Access Compliance Report

Public Rights-of-Way

(Curb Ramps)

Intersection ID: 45493	Main Street: BUGGY_HORSE_RD	Cross Street: TREE_CANOPY_RD	Location: S
ADA ID: CAA216B7A1FB	Ramp Type: PerpDiag	Initial Pass/Fail: Fail	Overall Compliance: No
		Severity Score: 22.5

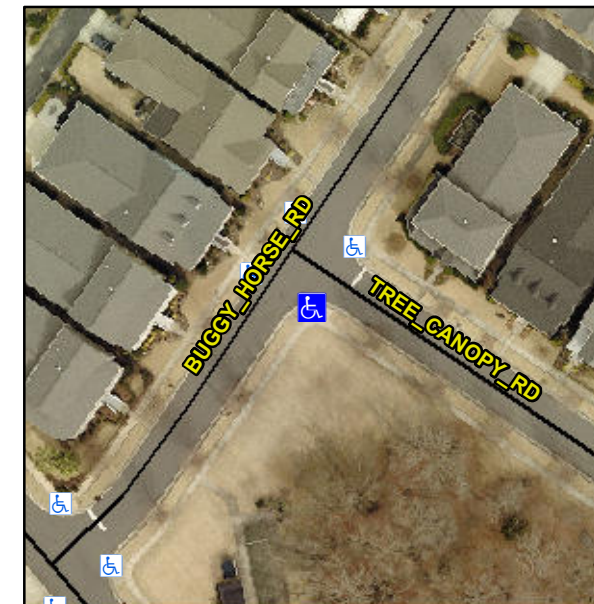
Not Found, R304.5.1, R304.2.2, R304.5.3

Compliance	Description	Data	Compliance	Description	Data
N/A	Ramp Length (in)	71.0	No	Ramp Slope (%)	10.3
No	Ramp Width (in)	38.0	No	Ramp XSlope (%)	2.3
N/A	Flare Type LT	N/A	N/A	Flare Type RT	N/A
N/A	Flare Slope LT (%)	N/A	N/A	Flare Slope RT (%)	N/A
N/A	Flare Traversable LT?	N/A	N/A	Flare Traversable RT?	N/A
N/A	Landing Length (in)	N/A	N/A	DWS Provided?	N/A
N/A	Landing Width (in)	N/A	N/A	DWS Contrast?	N/A
N/A	Landing Slope (%)	N/A	N/A	DWS Length (in)	N/A
N/A	Landing X Slope (%)	N/A	N/A	DWS Full Width?	N/A
N/A	Landing Curb? (Y/N)	N/A	N/A	DWS Offset (in)	N/A
N/A	Shared Landing?	N/A			
N/A	Gutter Ponding?	N/A	N/A	Gutter Slope (%)	N/A
N/A	Gutter Lip Ht (in)	N/A	N/A	Gutter X Slope (%)	N/A
N/A	Painted X Walk1?	No	N/A	Painted X Walk2?	No
	X Walk 1 Direction	To NE		X Walk 2 Direction	To NW
N/A	X Walk 1 Width (in)	N/A	N/A	X Walk 2 Width (in)	N/A
	X Walk 1 Slope (%)	1.6		X Walk 2 Slope (%)	2.3
	X Walk 1 X Slope (%)	1.7		X Walk 2 X Slope (%)	1.3

Remove & Replace Curb Ramp With Two New Directional Ramps or Equivalent.
